Adjustment of Transition Time for RX Interference Tolerance Test in KR and C2C (Comment #138)

IEEE P802.3ck Task Force
May, 2021

Comment #138 (overview)

Figure 93C-2—Interference tolerance test setup

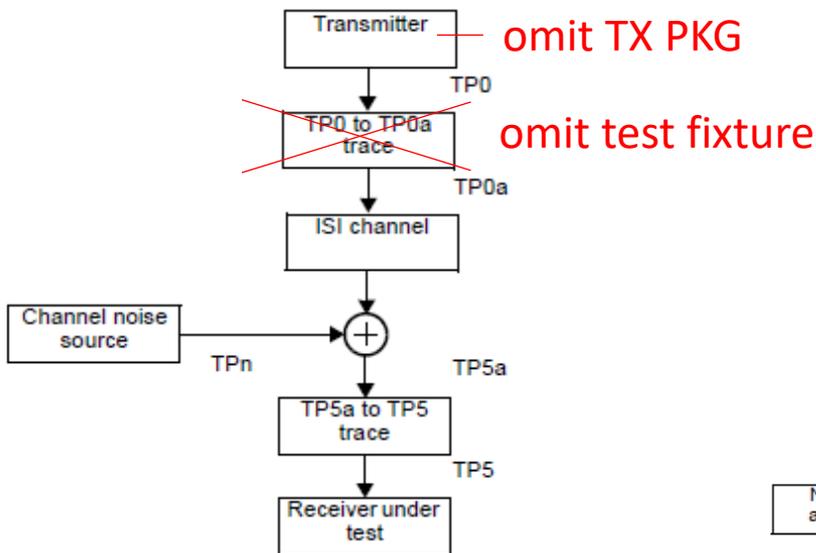
When TX is a BERT

- ❖ In this case, T_r at the COM signal source (=TP0) is directly measurable.
- ❖ Omitting TP0 to TP0v (replica) trace (in addition to package model) and skipping calibration of T_r is **possible, simpler and more accurate** than calibrating T_r at the COM signal source against T_{rm} measured at TP0v.

Figure 163-X – Interference tolerance test setup using an instrument-grade transmitter

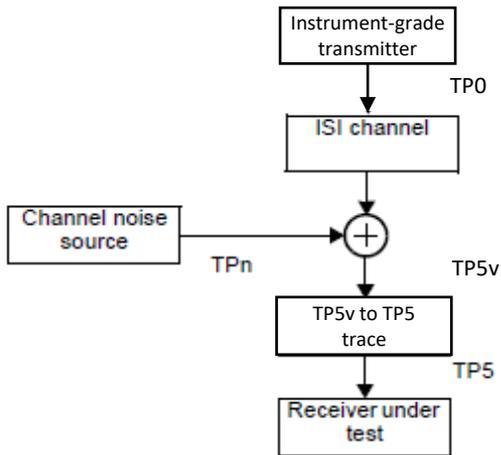
Proposed figures in 163.9.3.4

- Change step e in clause 163.9.3.4 as follows:

In the calculation of COM, if the transmitter is a device with known S-parameters and transition time T_r , these parameters should be used instead of the transmitter package model in 93A.1.2. If a calibrated instrument-grade transmitter is used, the transmitter device package model $S^{(tp)}$ is omitted from Equation (93A-3), Figure 163-X replaces Figure 93C-2, Figure 163-Y replaces Figure 93C-3, Figure 163-Z replaces Figure 93C-4, and T_r in Equation (93A-46) is same as the measured transition time T_{rm} of the signal source at TP0 using the test setup in Figure 163-Y. If the transmitter is not a device with known S-parameters and transition time nor a calibrated instrument-grade transmitter, T_r in Equation (93A-46) is calibrated per Figure 163-W so that the reference transition time $T_r^{(ref)}$ calculated according to 163A.3.1.X matches to the measured transition time T_{rm} of the signal at TP0v using the test setup in Figure 93C-3 including TP0 to TP0v trace. ~~in the calculation of COM. The filtered voltage transfer function $H^{(k)}(f)$ calculated in Equation (93A-19) uses the filter $H_{\frac{1}{\epsilon}}(f)$ defined by Equation (93A-46), where $T_{\frac{1}{\epsilon}}$ is calculated as $T_{\frac{1}{\epsilon}} = 1.09 \times T_{\frac{1}{\epsilon}}$ 4.32 ps and $T_{\frac{1}{\epsilon}}$ is the measured 20% to 80% transition time at TP0v. The measured transition time T_{rm} is measured with the transmitter equalizer turned off and using the method in 120E.3.1.5. $T_{\frac{1}{\epsilon}}$ is measured with the transmitter equalizer turned off.~~

Figure 163-W – Calibration of risetime T_r at signal source against measured transition time T_{rm}

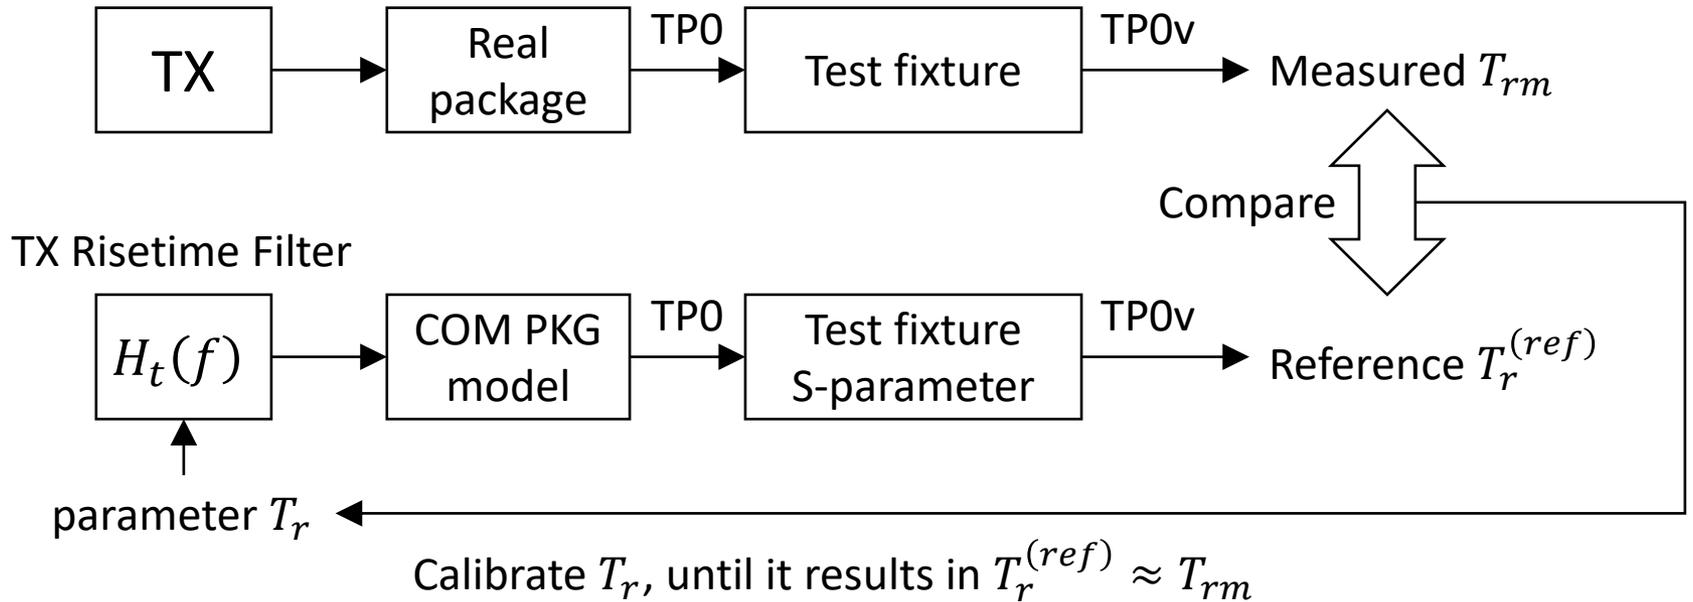
When TX is not a BERT nor known S-parameters and transition time

- ❖ T_r at the signal source must be calibrated so that reference transition time $T_r^{(ref)}$ at TPOv matches to the measured transition time T_{rm} at TPOv.

Outline of Calibration of T_r in Equation (93A-46)

1. Measure T_{rm} at TP0v using the method in 120E.3.1.5.
2. Calibrate T_r in Equation (93A-46) so that $T_r^{(ref)} \approx T_{rm}$.

Here, $T_r^{(ref)}$ is the reference transition time at TP0v according to a new subclause 163A.3.1.X calculated from the following parameter and functions (see slide 10 for detail):

- Estimated value of T_r .
- TX risetime filter $H_t(f)$ (Equation (93A-46)).
- Reference device and package model $S^{(tp)}(f)$.
- S-parameter of test fixture $S^{(fixt)}(f)$.

For $S^{(tp)}(f)$, use the longer trace length for consistency with the definition of $v_f^{(ref)}$.
